Planning Commission Public Hearing Report

- Meeting Date:** June 12, 2019
- From:** Andrew Stanislav, Planner 
- Location:** A 4.76 acre tract of land located on the south side of Old Clarkson Road approximately 900 feet from its intersection with Baxter Road
- Petition:** **P.Z. 07-2019 15750 Old Clarkson Rd (Kumara S. Vadivelu)**: A request for a zoning map amendment from the “E-1/2AC” Estate Half Acre District to a “PUD” Planned Unit Development for a 4.76 acre tract of land located on the south side of Old Clarkson Road approximately 900 feet from its intersection with Baxter Road (19S130015).

Kumara S. Vadivelu of Azack Construction has submitted a request for a zoning map amendment from “E-1/2AC” Estate Half Acre District to a “PUD” Planned Unit Development as part of a two-step zoning process for a 4.76 acre tract of land located on the south side of Old Clarkson Road approximately 900 feet from its intersection with Baxter Road.

SITE, PAVING AND UTILITY PLAN

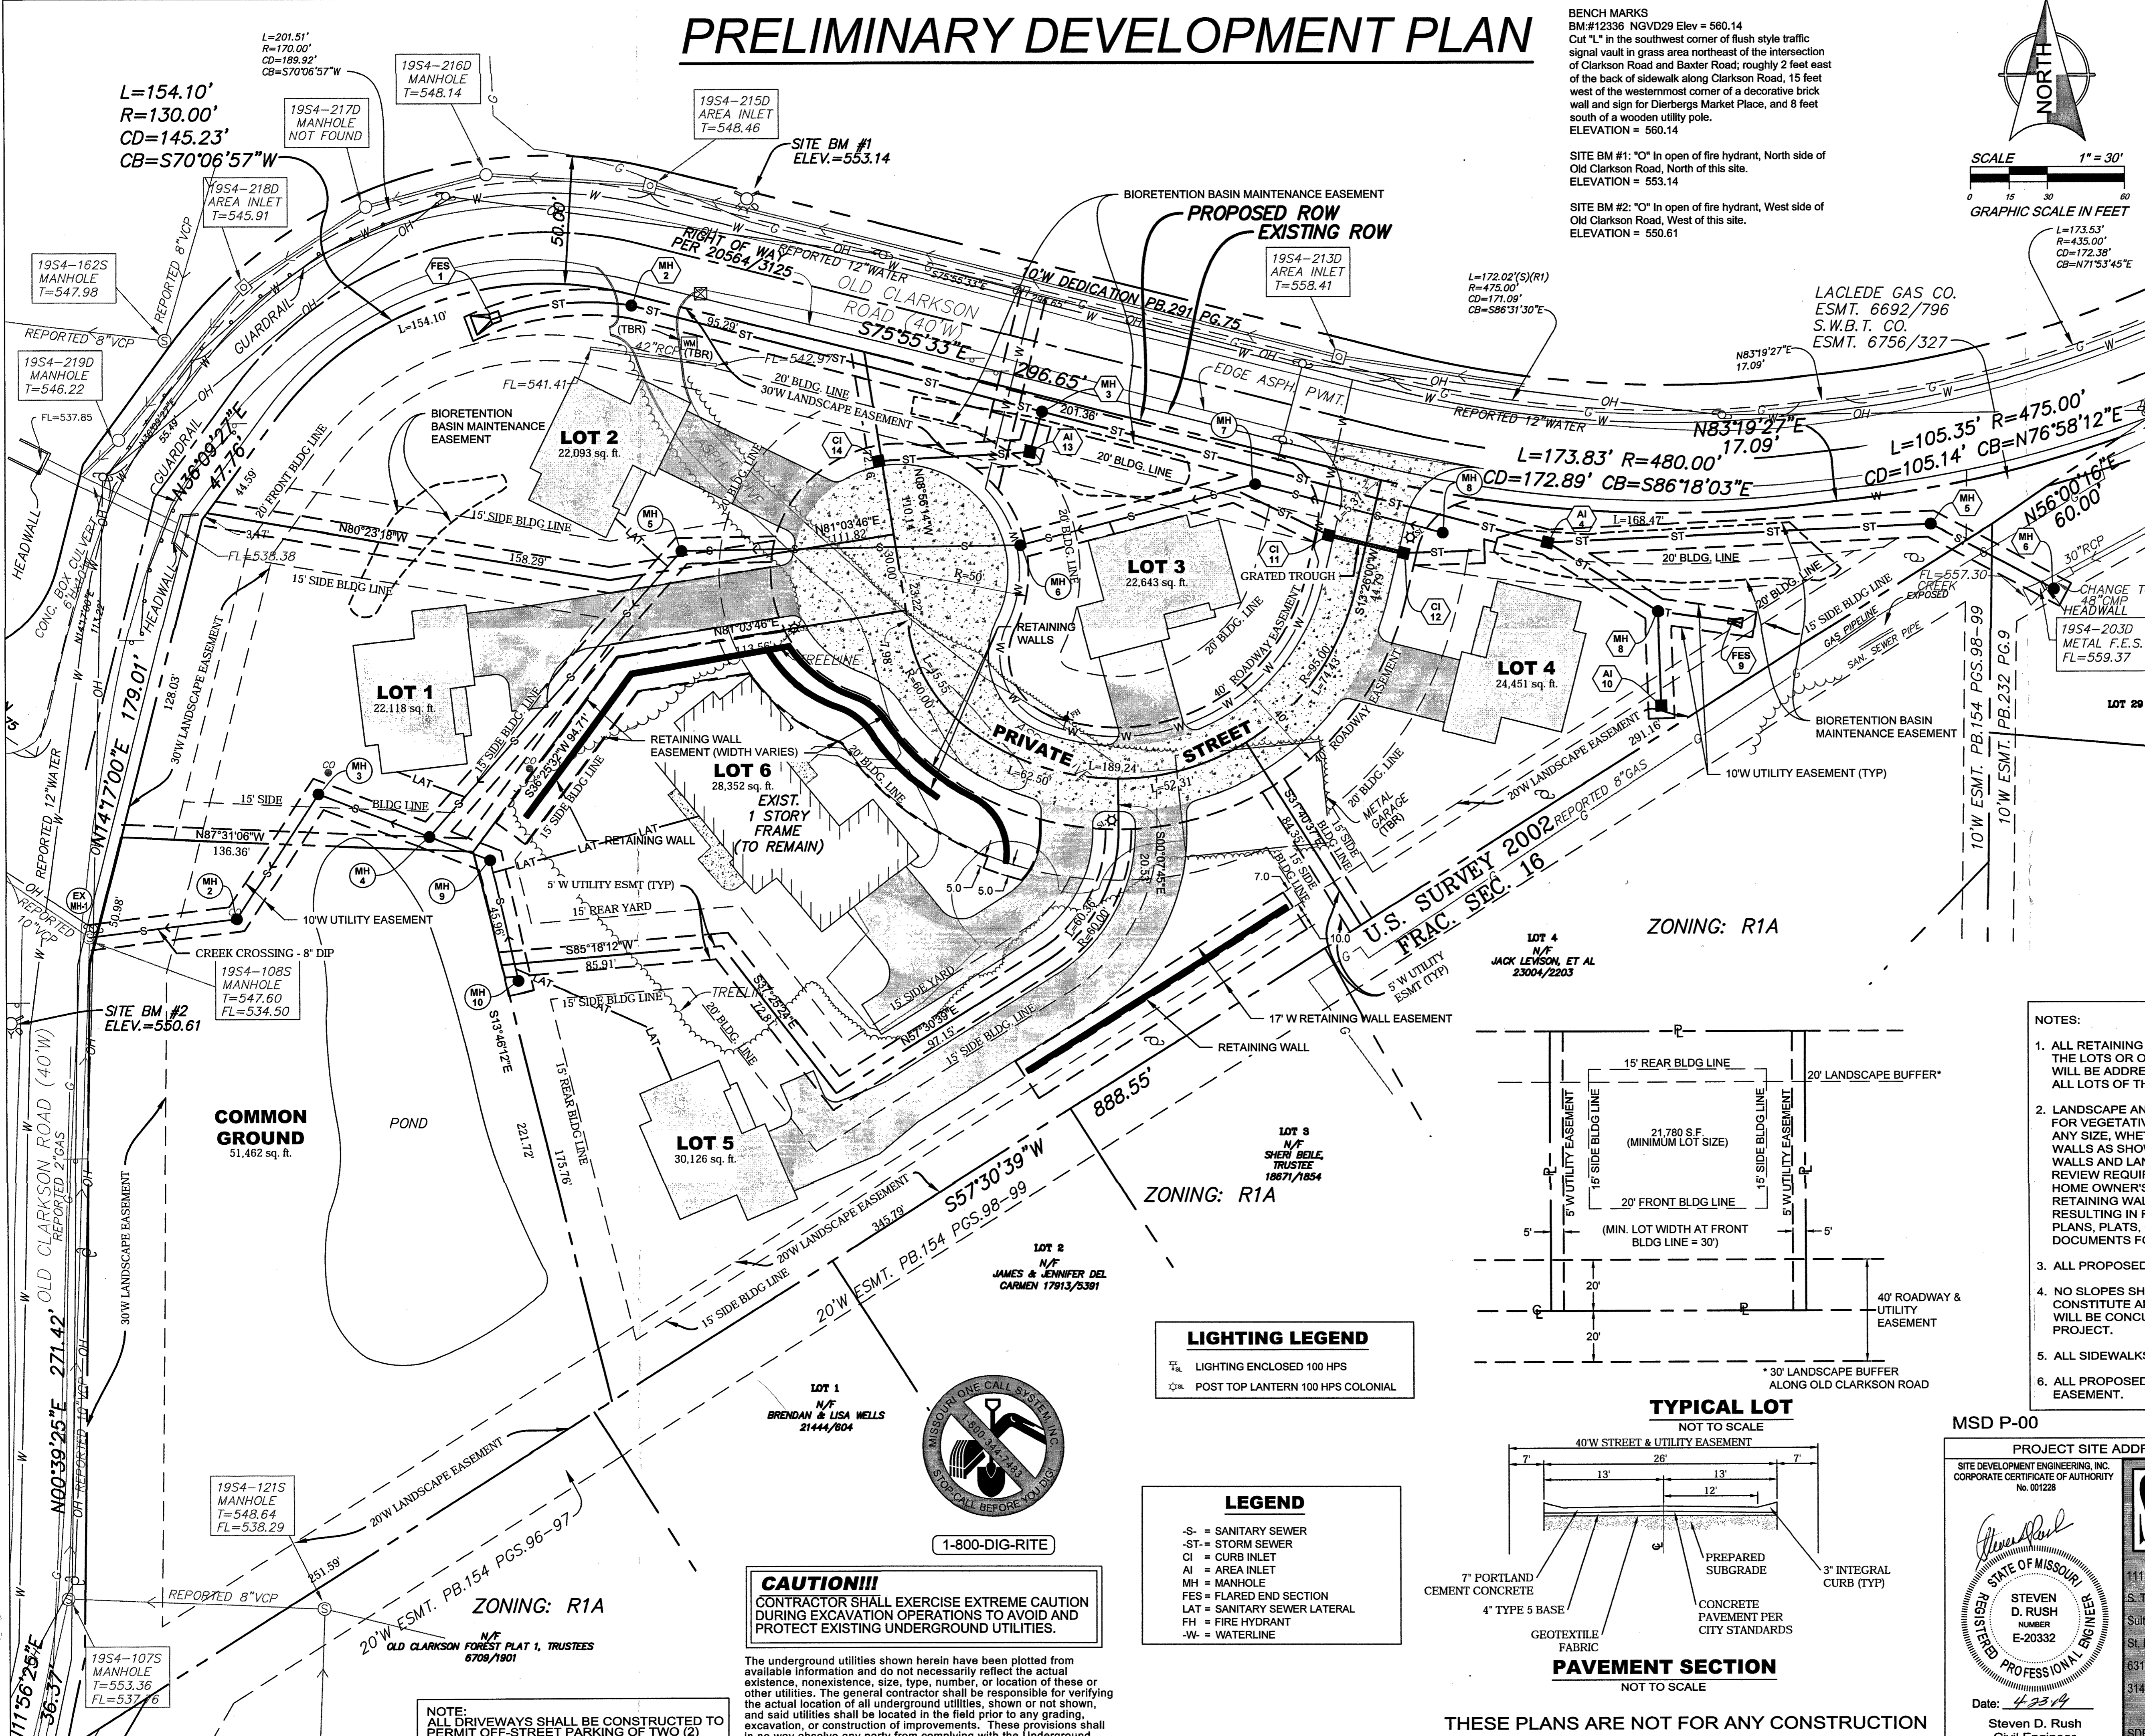
The PUD proposal currently includes 1.18 acres of common open space, or 24.8 percent of the total site. Proposed common ground is concentrated in the area surrounding the existing pond as depicted on the Preliminary Plan. A request for a modification to any of the PUD minimum design standards will require a two-thirds (2/3) vote by the Planning Commission.

The Preliminary Plan includes a 30 foot wide landscape buffer along Old Clarkson Road and a 20 foot wide landscape buffer along the southern property line abutting the Old Clarkson Forest subdivision. A request for a modification to any of the PUD minimum design standards will require a two-thirds (2/3) vote by the Planning Commission.

The proposed buffers are also depicted as part of the lots as opposed to dedicated common ground as seen in other PUDs previously approved in the City. A conceptual landscape plan is forthcoming from the developer as required for a PUD.
